SUBJECT: Notification of Class 1 Permit Modification to Update Figures in the Los Alamos National Laboratory (LANL) Hazardous Waste Facility Permit

**Class 1 Permit Modification to Update Figures in the Los
Alamos National Laboratory (LANL) Hazardous Waste
Facility Permit**

LA-UR-17-22537

Figure G.12-1: Technical Area 54, Area G, Pad 11 Outdoor Container Storage Unit Grid Sampling and Additional Sampling Locations

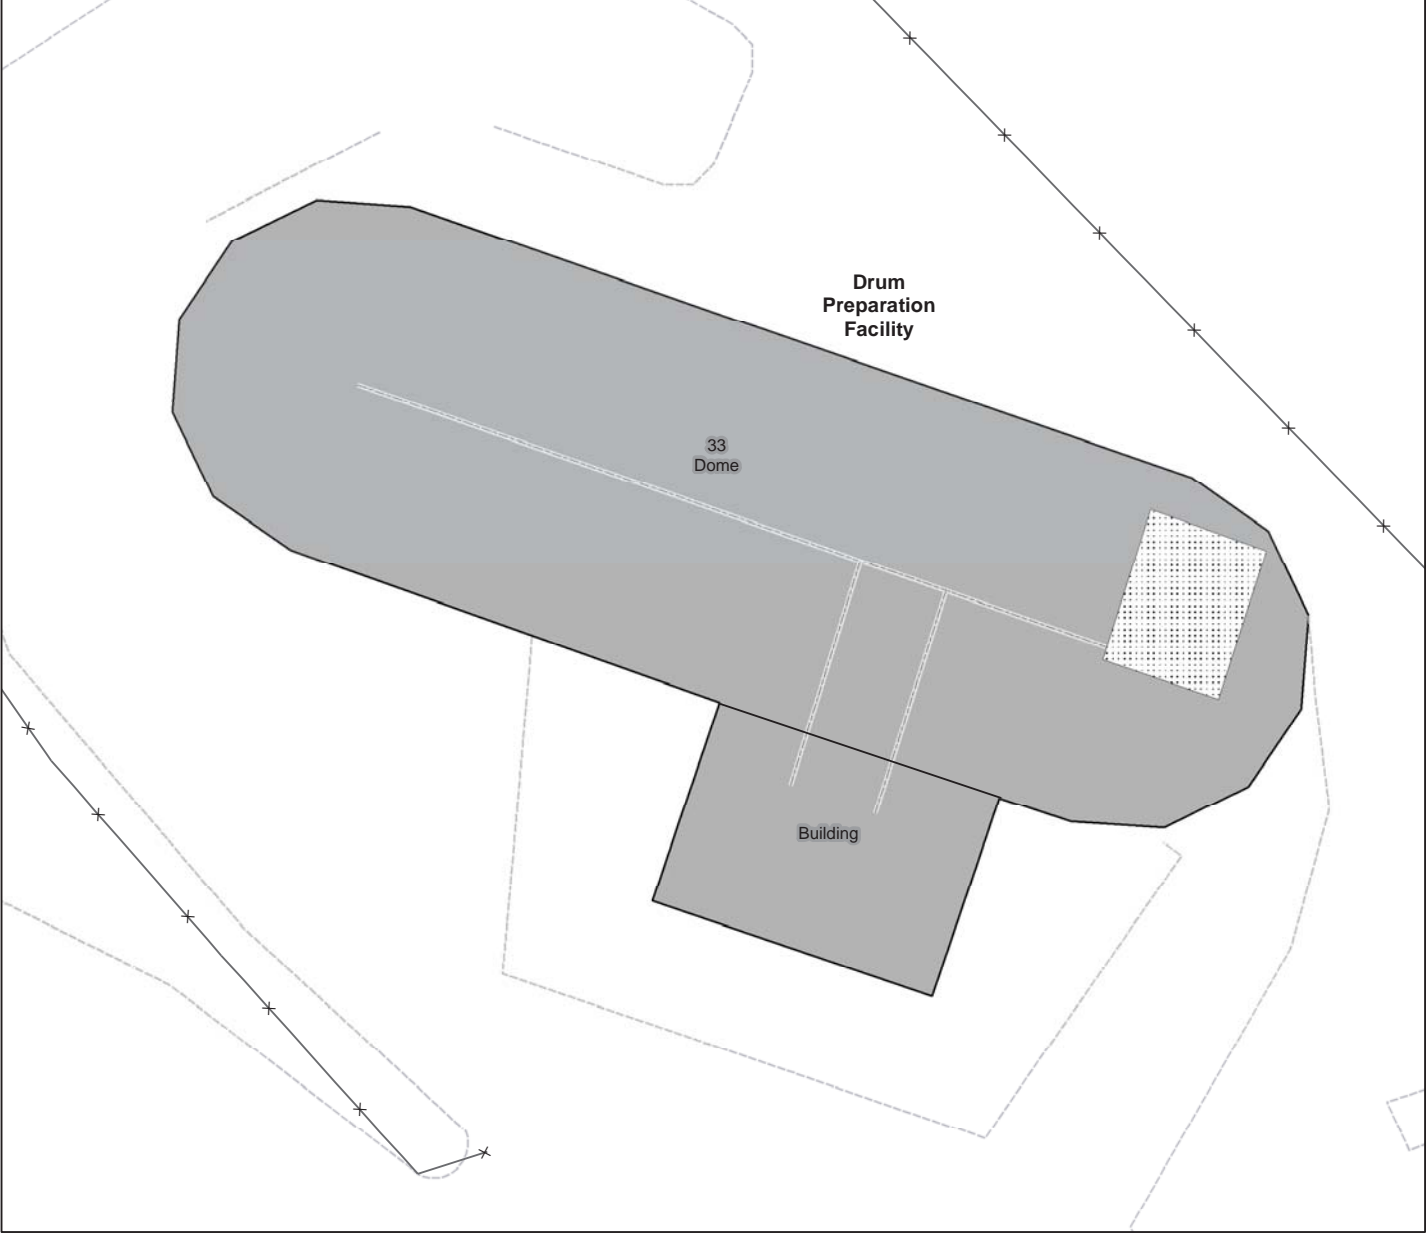
Figure 36 (*Technical Area (TA)-54, Area G, Pad 11*) of Attachment N and Figure G.12-1 (*Technical Area 54, Area G, Pad 11 Outdoor Container Storage Unit Grid Sampling and Additional Sampling Locations*) of Attachment G.12 were revised to accurately reflect the location and orientation of a restroom trailer that is located on Pad 11. Figure 36 and Figure G.12-1 currently show the restroom trailer as being oriented in the north-south direction; however, the restroom trailer is situated on the permitted unit in the east-west direction. The above mentioned figures have been updated to reflect this change.

Figure 36 and Figure G.12-1 were also revised to reflect the addition of a transportainer to the east Dome 375. This structure is situated on the permitted unit to serve as storage for tools and equipment; it will not be used to store or manage hazardous waste.

Figure 35
Technical Area (TA)-54, Area G, Building 33

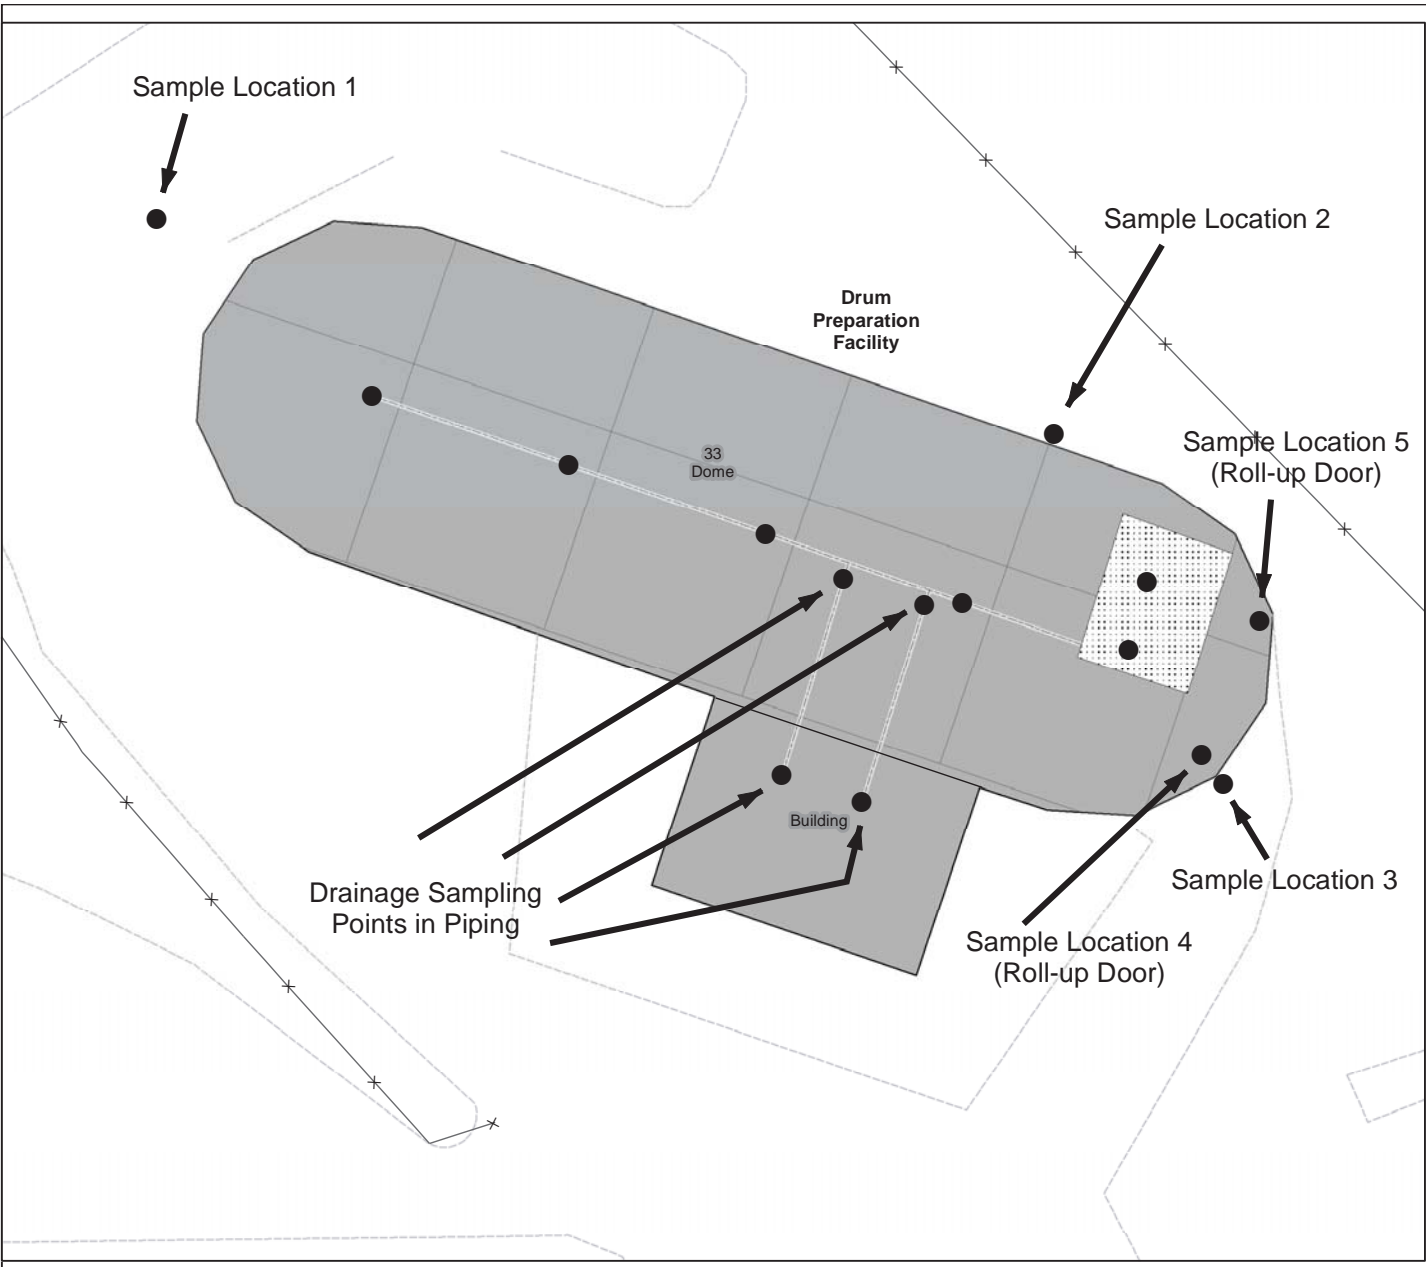
Figure 35 (*Technical Area (TA)-54, Area G, Building 33*) of Attachment N and Figure G.14-1 (*Technical Area 54, Area G, Building 33, Indoor Container Storage Unit Grid Sampling and Additional Sampling Locations*) of Attachment G.14 were revised to remove structure 481, which was erroneously depicted as being located northwest of the permitted unit. Structure 481, a support structure that is not associated with hazardous waste management at a permitted unit, is located within the permitted boundary of Pad 6 and is accurately depicted in the figures associated with that permitted unit.

Figure G.14-1: Technical Area 54, Area G, Building 33, Indoor Container Storage Unit Grid Sampling and Additional Sampling Locations

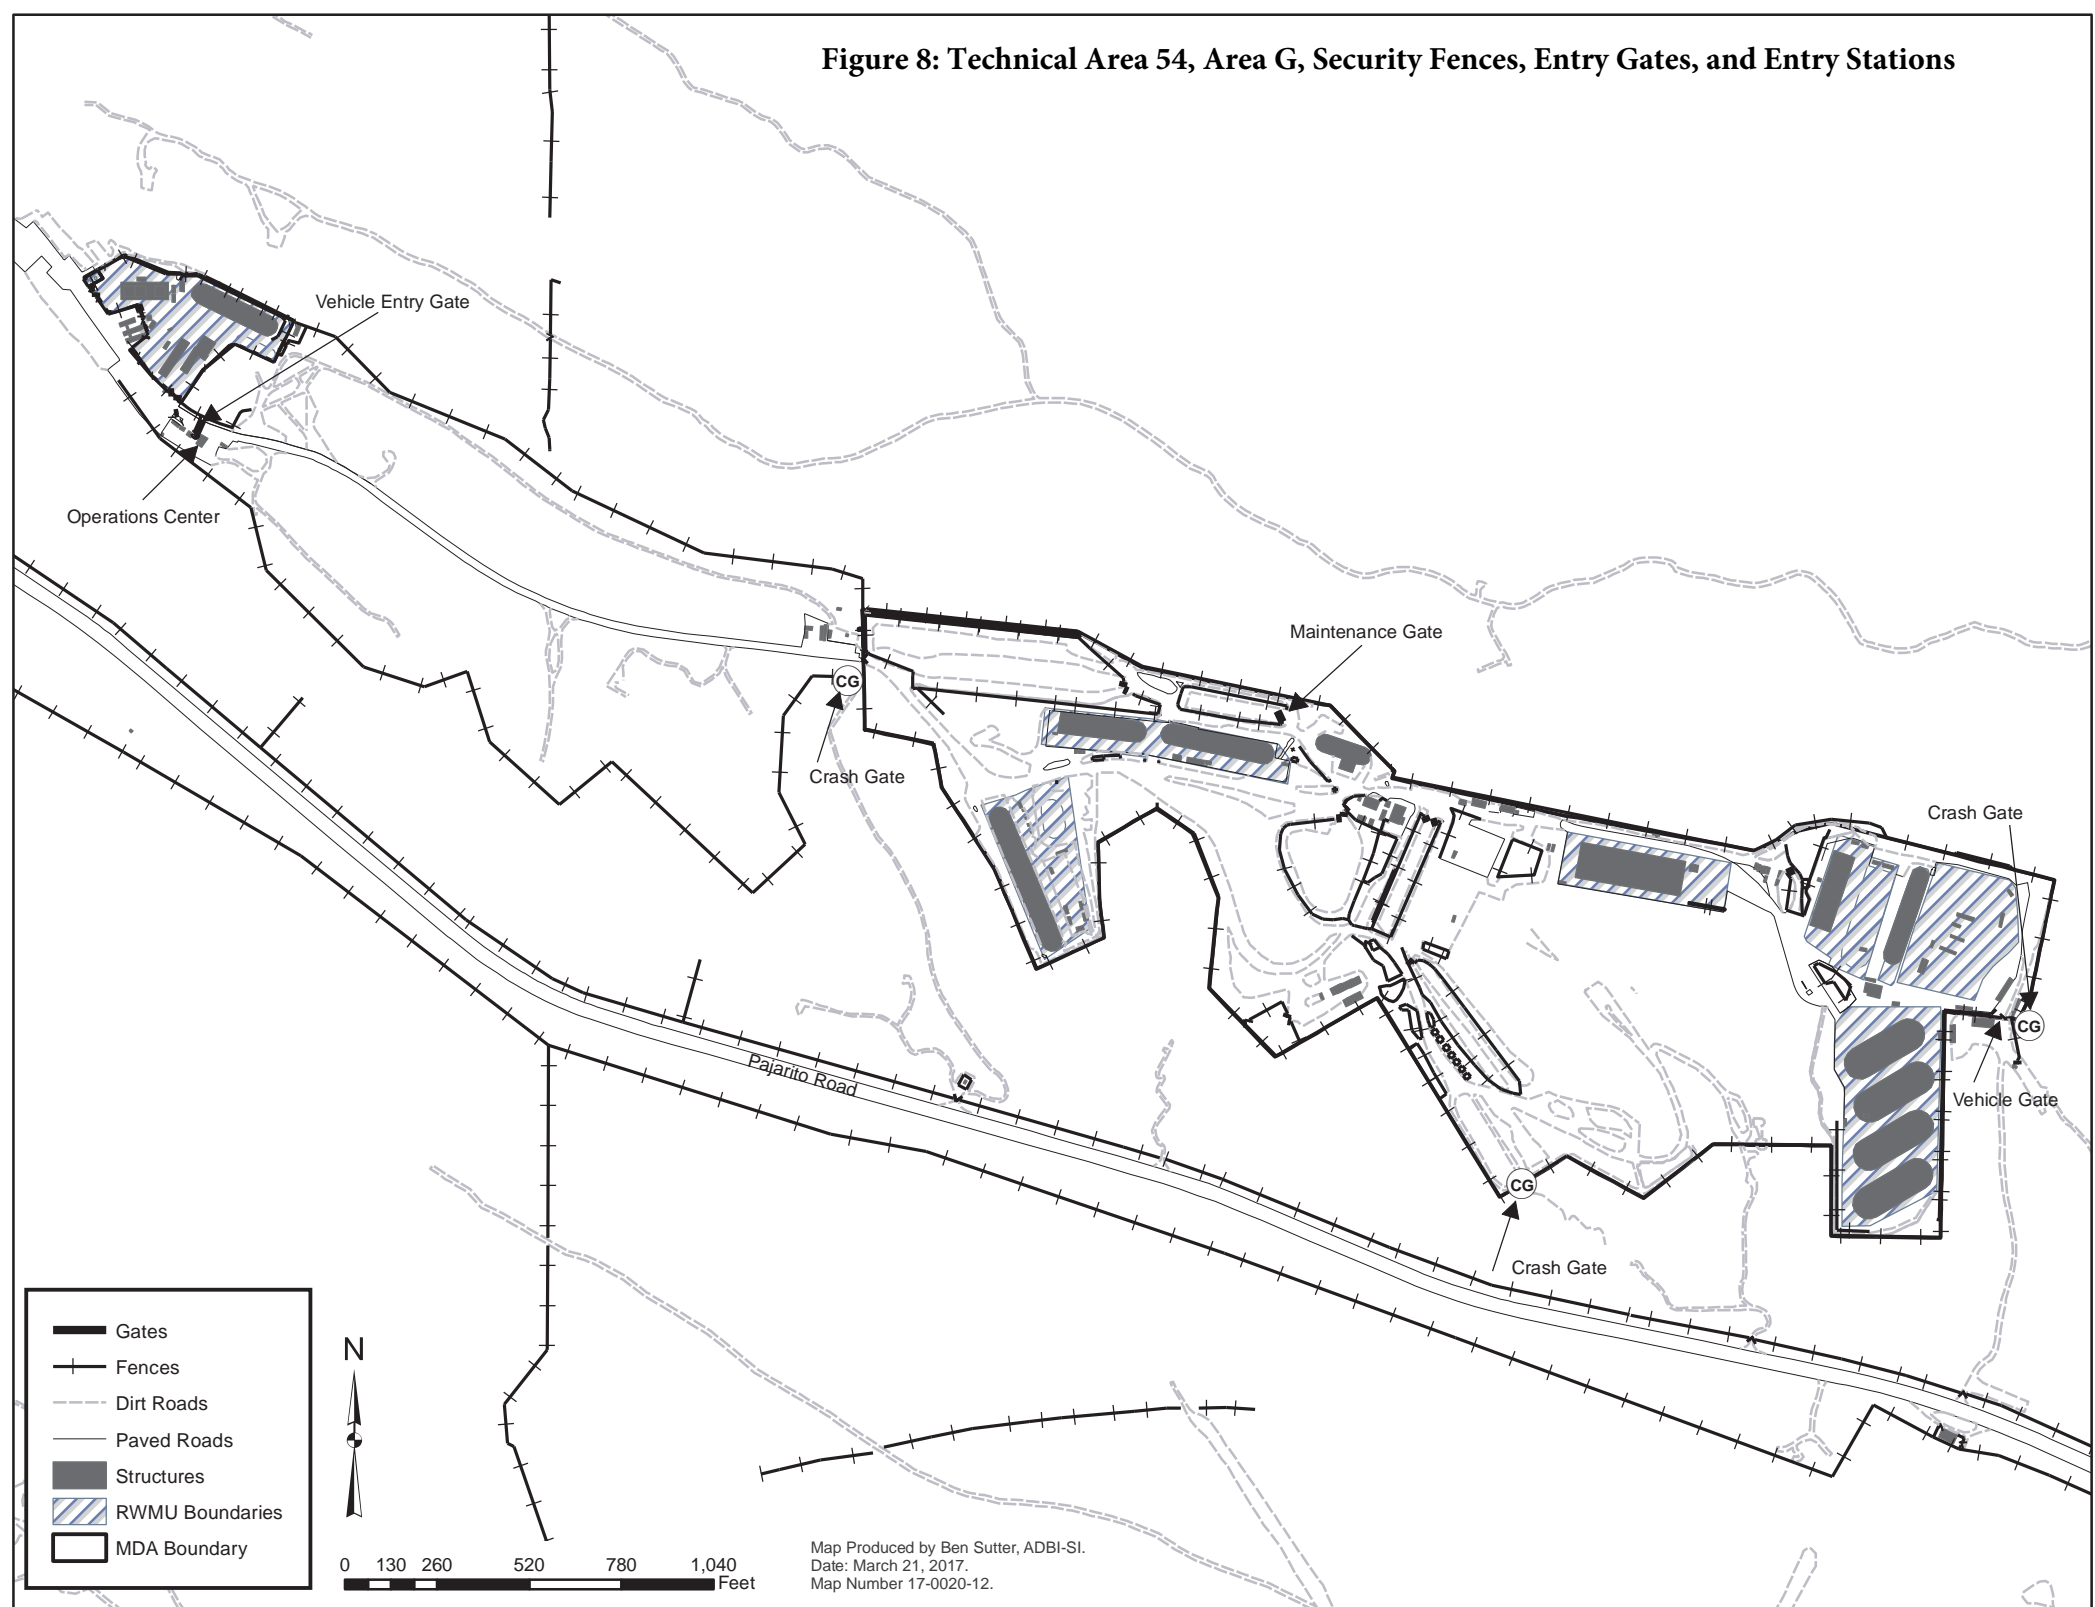
An additional revision to Figure G.14-1 includes the removal of structure 377. This structure was relocated to Pad 1 in a previous permit modification; however, the polygon representing the structure in its original location was never removed.

Figure 8: Technical Area 54, Area G, Security Fences, Entry Gates, and Entry Stations

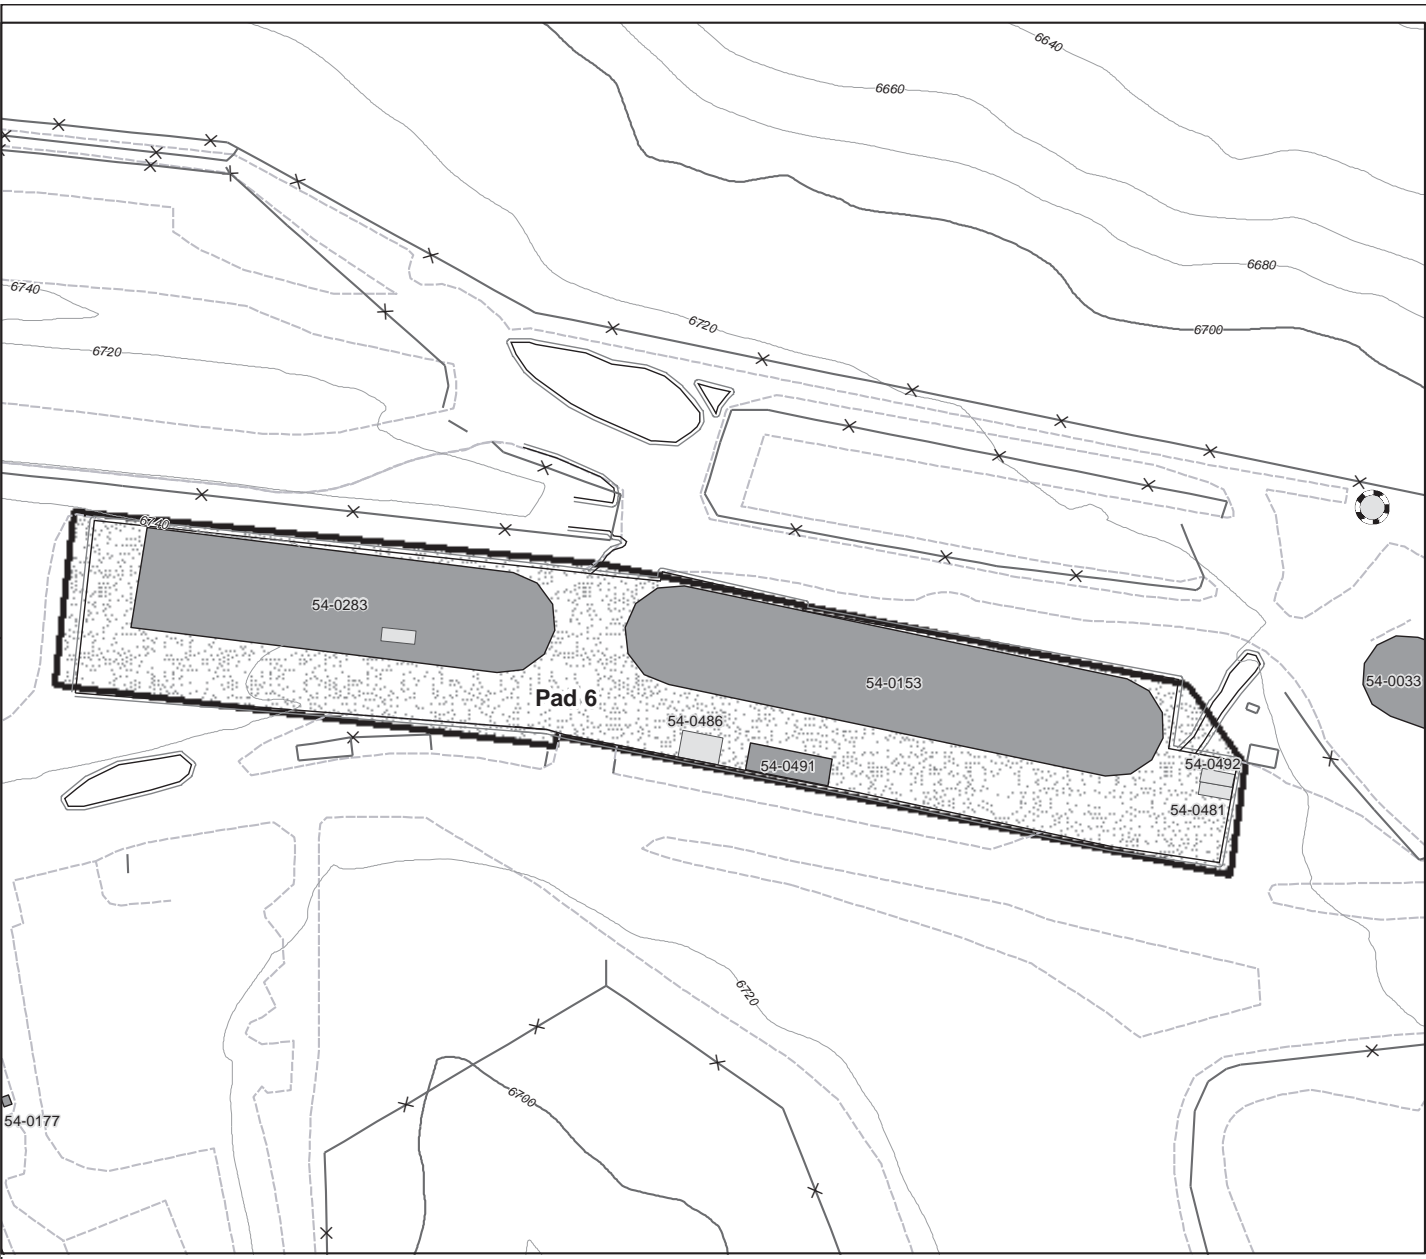
Figure 8 (*Technical Area 54, Area G, Security Fences, Entry Gates, and Entry Stations*) of Attachment N was revised to reflect the removal of Dome 224 at Technical Area 54, Area G, Pad 5. A Class 1 permit modification request to remove Dome 224 from the Los Alamos National Laboratory Hazardous Waste Facility Permit was approved by the New Mexico Environment Department on January 20, 2017. Figure 8 of Attachment N has been revised to reflect this change.

Additional changes to Figure 8 include the removal of two structures: TA-54-0497 Real-time Radiography System #2 (RTR2) and TA-54-0506 Canberra Multi-Channel Scaling High Efficiency Neutron Counter (MCS HENC) from Technical Area 54, Area G, Pad 10. A Class 1 permit modification request to remove these structures from the Los Alamos National Laboratory Hazardous Waste Facility Permit was approved on October 24, 2016.

Figure 33: Technical Area (TA)-54, Area G, Pad 6, (Domes 153 & 283)

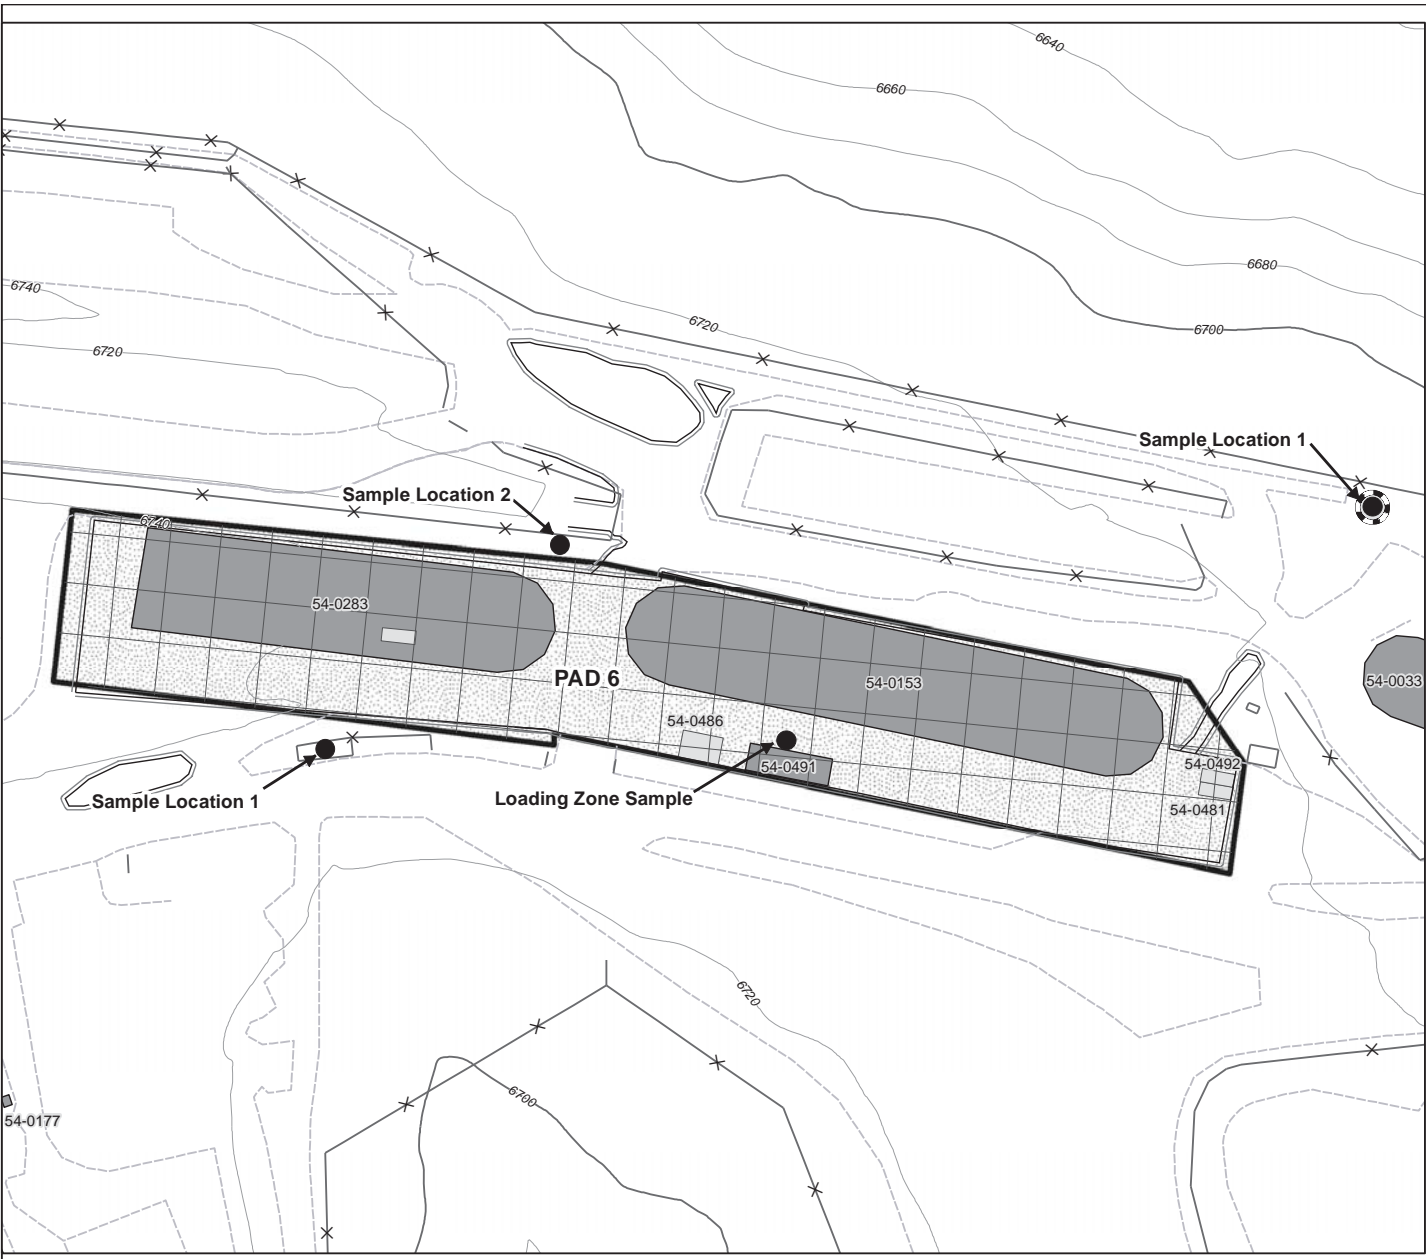
Figure 33 (*Technical Area (TA)-54, Area G, Pad 6, (Domes 153 & 283)*) of Attachment N and Figure G.9-1 (*Technical Area 54, Area G, Pad 6 Outdoor Container Storage Unit Sampling Grid and Additional Sampling Locations*) of Attachment G have also been revised to reflect the removal of Dome 224 at Technical Area 54, Area G, Pad 5.
